REQUEST FOR CLARIFICATIONS

RADIATION PROTECTION PLAN

Figure 2.6. Quantitative Dispersion Factors

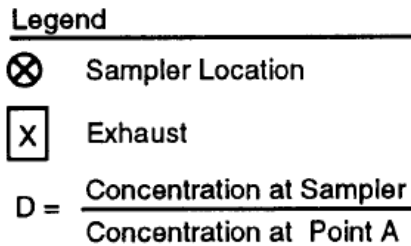
In considering an appropriate dispersion factor for particles that do not tend to become airborne, Figure 2.6 of NUREG-1400 was reviewed. This figure provides an example where quantitative dispersion factors are determined directly through air sampling. Although quantitative values cannot be determined at this time, NUREG-1400 supports use of dispersion factors less than 1.

The NRC staff reviewed Figure 2.6 of NUREG-1400 and can't corroborate the licensee's interpretation. Figure 2.6 is related to Section 2.2.2.2 of NUREG-1400 discussing quantitative airflow studies. Figure 2.6 is related to the dispersion of aerosols from the source of a release:

The “D” in Figure 2.6 is referred to as the “dispersion factor”. This is not the same as the “dispersibility factor” discussed in Section 1.2.3 of NUREG-1400 for determining potential intakes.

Provide a justification for the use of a dispersibility factor (D) less than 10 that is consistent with Section 1.2.3 of NUREG-1400 for determining potential intakes.

The potential intake calculation provided in Appendix A of the RPP discusses the rationale for using a value for dispersibility of 0.1. NUREG-1400 describes dispersibility (D) in Section 1.2.3 as follows:

Another factor that may be appropriate to consider is the dispersibility that comes from adding energy to the system through grinding, milling, boiling, or exothermic chemical reactions. A dispersibility factor D of 10 can be applied to the calculation if cutting, grinding, heating, or chemical reactions of materials are performed.

NUREG-1400 specifically indicates that dispersibility factor of 10 is applied to operations involving the addition of energy to the system. Processing of resin does not add energy to the system as currently designed and described in the Decommissioning Plan. As discussed in Appendix A of the RPP, a factor of 0.1 was used because, based on professional judgement, sluicing spent resin and blending it with absorbent in an enclosed low-energy blender is an operation that does not involve sufficient likelihood of dispersing the contaminant in air to consider dispersibility more than a negligible factor. If a more conservative factor of $D = 1$ was used to represent dispersibility as essentially a non-factor, instead of 0.1, the potential intake would be 1.1% ALI. This value still supports the air monitoring regime described in the RPP. Appendix A will be updated to incorporate $D = 1$, which is reasonably conservative for an enclosed system where energy is not added. This change has no effect on other provisions related to air sampling and internal dose monitoring already provided in the RPP.
